Case Number: R18028

**CASE COMMENTS:**

**Prior to Final DRC sign-off, please provide updated plans and written response to the following review comments:**

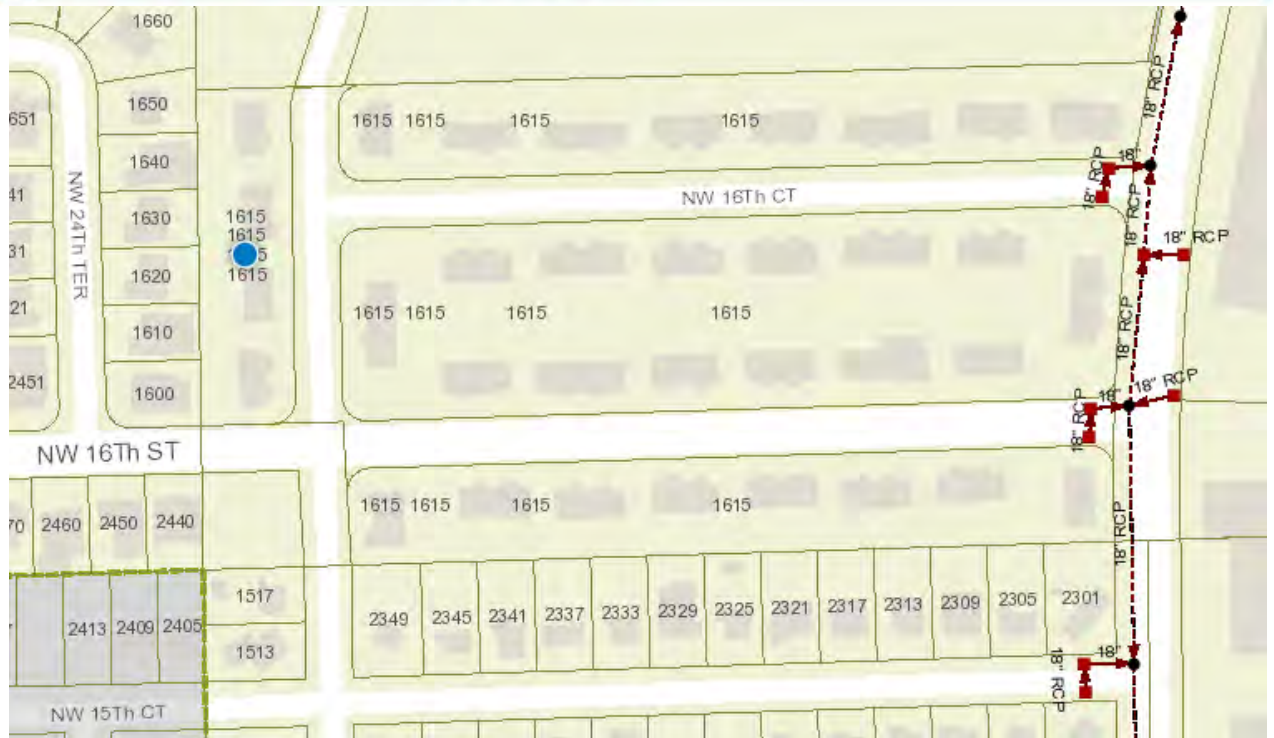
**DEDICATION OF RIGHTS-OF-WAY:** Per ULDR Section 47-25.2.M.5, property shall be conveyed to the public by plat, deed or grant of easement as needed in accordance with the Broward County Trafficways Plan, the city's comprehensive plan, subdivision regulations and accepted applicable traffic engineering standards:

- a. Provide 5' Right-of-Way dedication or permanent Right-of-Way Easement along west side of NW 23<sup>rd</sup> Avenue (coordinate with BCHCED), to complete half of 80' Right-of-Way section per the most current Broward County Trafficways Plan; show / label delineation in the plans. Clarify with BCHCED if Right-of-Way dedication (which may affect building setbacks) or Right-of-Way Easement (which doesn't affect building setbacks) will be required.

- b. Provide 25' corner chord Right-of-Way dedication or permanent Right-of-Way Easement on southwest corner of NW 23<sup>rd</sup> Avenue & NW 16<sup>th</sup> Street intersection (coordinate with BCHCED) per ULDR Section 47-24.5.D.p; show / label delineation in the plans. Clarify with BCHCED if Right-of-Way dedication or Right-of-Way Easement will be required.

- c. Provide 20' corner chord permanent Right-of-Way Easement on southeast corner of NW 16<sup>th</sup> Street & NW 24<sup>th</sup> Avenue intersection per ULDR Section 47-24.5.D.p; show / label delineation in the plans.

- d. Provide permanent Sidewalk Easement as appropriate along south side of NW 16<sup>th</sup> Street to accommodate portion of pedestrian clear path (coordinate required width with TAM) that may be located beyond public Right-of-Way; show / label delineation in the plans.

- e. Provide permanent Sidewalk Easement as appropriate along east side of NW 24<sup>th</sup> Avenue to accommodate portion of pedestrian clear path (coordinate required width with TAM) that may be located beyond public Right-of-Way; show / label delineation in the plans.

- f. Provide 10' x 15' (min.) permanent Utility Easement for any 4 Inch or larger water meter and/or the first private sanitary sewer manhole located within the proposed development (for City Maintenance access); show / label delineation in the plans as appropriate.
